PB# 98-35

ROCK TAVERN GREENS
LOT #24

SUBJECT: ROCK TAVERN GREEN SUBDIV.
NWPB FILE 98-35

**TOWN OF NEW WINDSOR
PLANNING BOARD
REVIEW COMMENTS**

SHEET NO. 1 OF 2

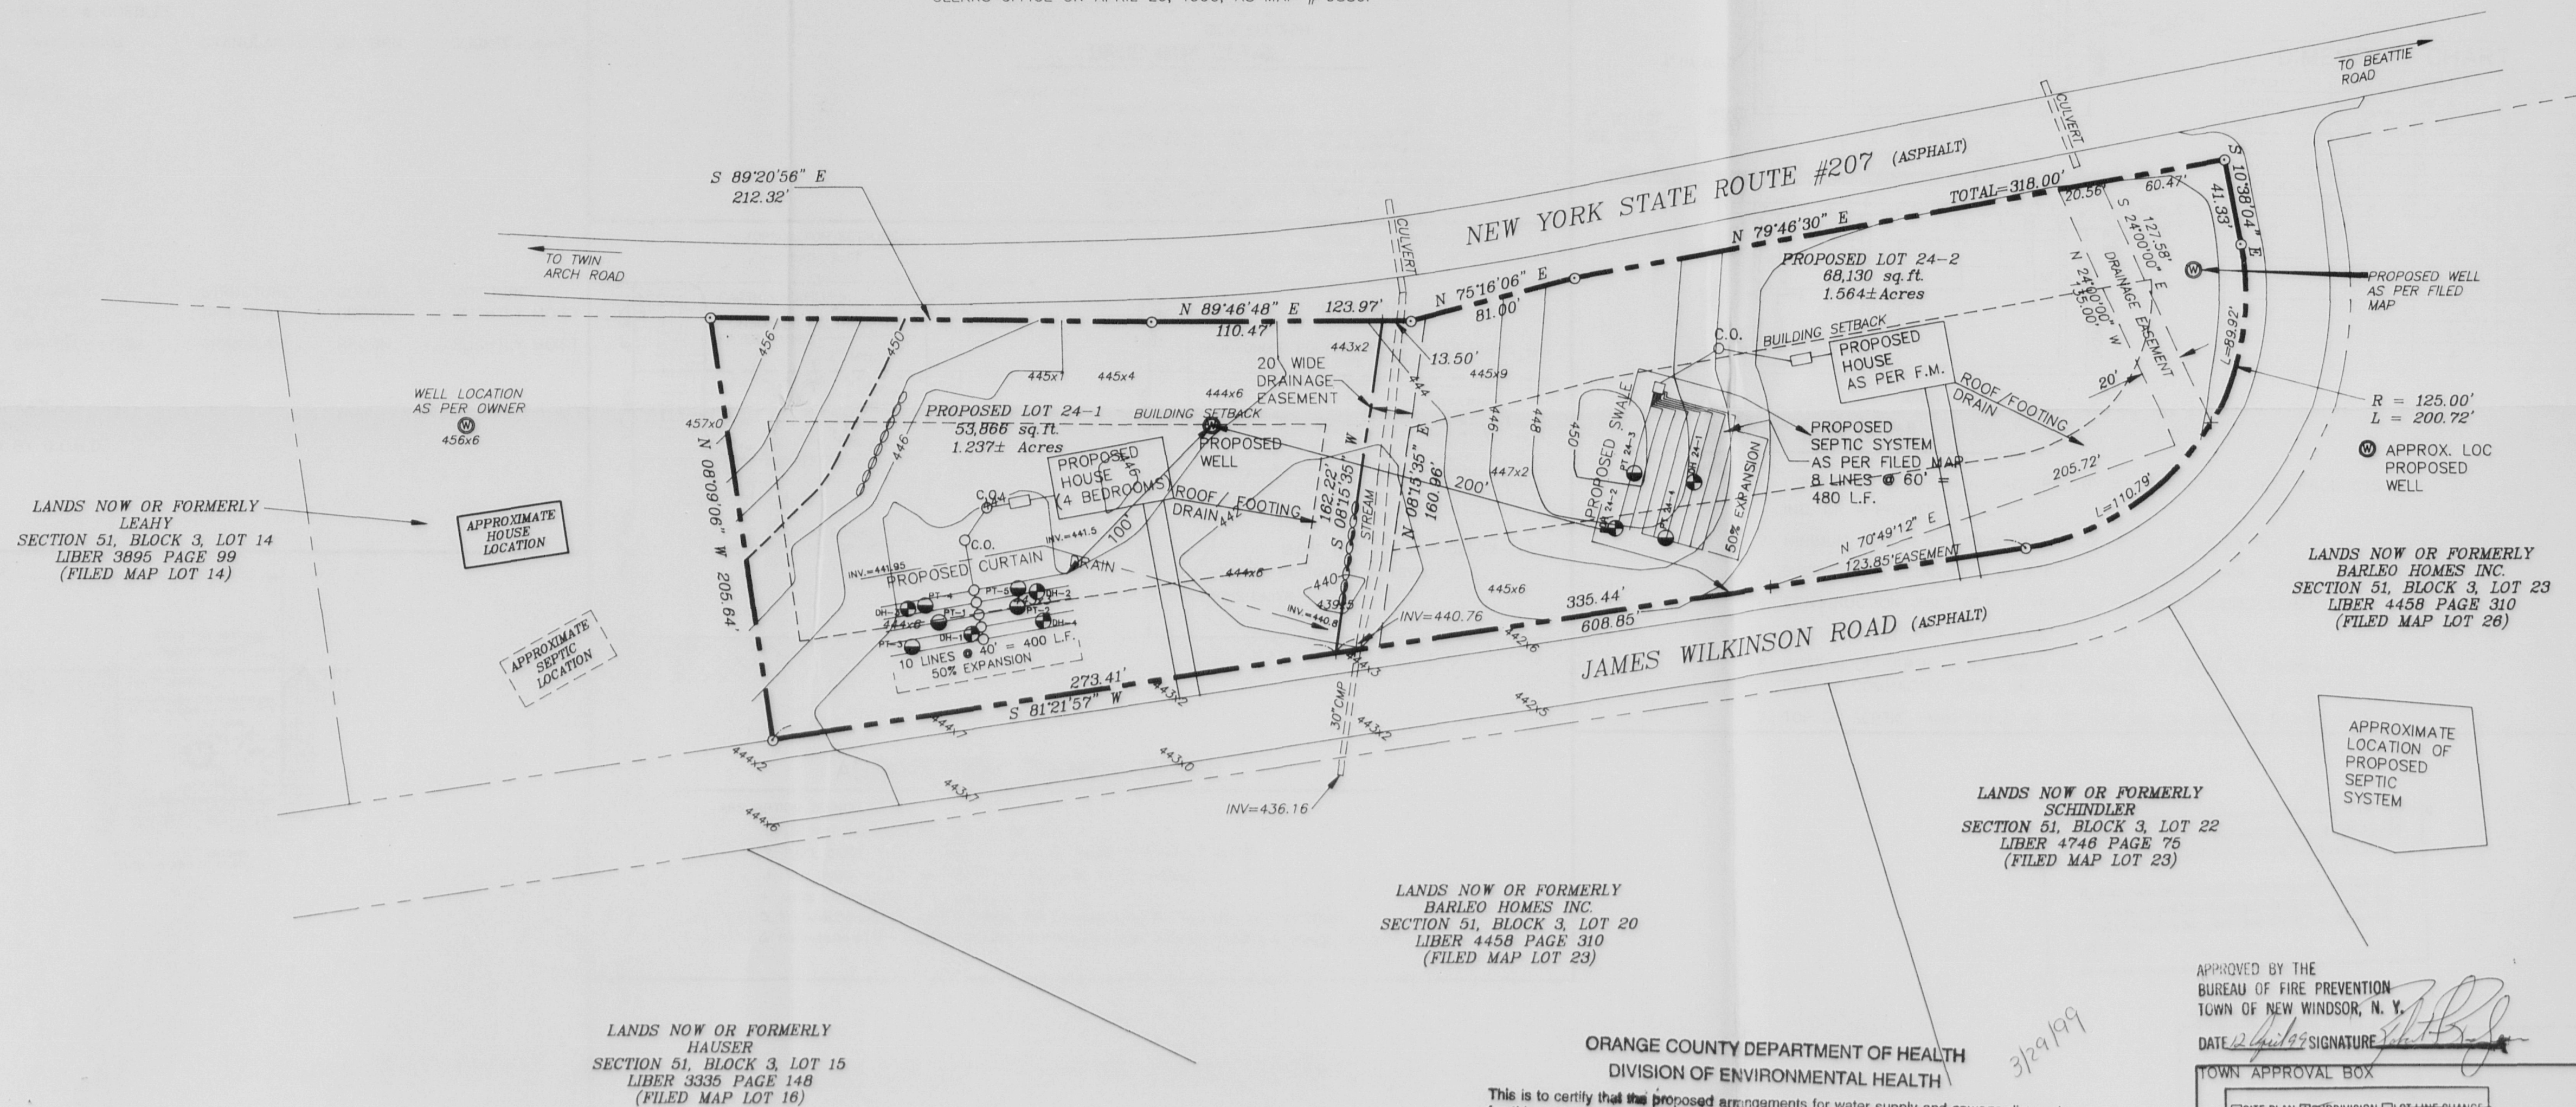
MR. EDSALL: There was a number of bulk items on proposed values that on the previous plan were incorrect and the new table seems to have some new numbers but there are still some numbers that need to be fixed. Several of them and I think it's just a matter of maybe not understanding how New Windsor measures different criteria like lot width also which had the one lot has three front yards and one side yard so there's no rear yard so I think we can probably work with him on getting the bulk table corrected. I don't believe there's any compliance problem, but I want the plan to appear correct, the one that is on record.

Need note on map for stream ~~dir~~ + drainage

The "required" bulk information shown on the plan appears correct for the zone and use group. Some corrections are necessary to the "proposed" bulk values.

add full bulk table.
